| Project | IEEE 802.16 Broadband Wireless Access Working Group < http://ieee802.org/16 > | |
| Title | Version Information Collection Primitives for Configuration Management | |
| Re: | Contribution on comments to IEEE 802.16g-05/008 | |

Figure xxx BS initiats version information update

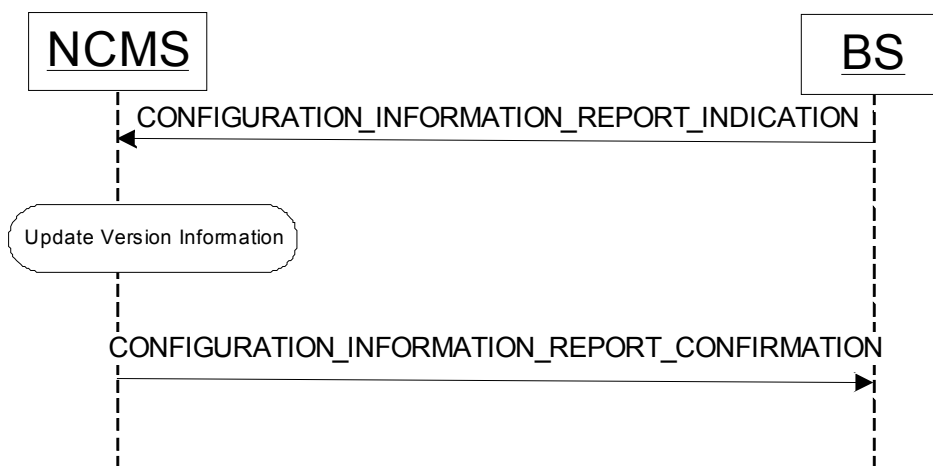
When the version information of one element is changed, the BS shall send the latest information to NCMS. The NCMS shall log the latest information and notify the user that the version information of one element in BS is changed. At the same time the NCMS shall response with success log or not. This is a procedure of initiating inquiry, as figure xxx shows.
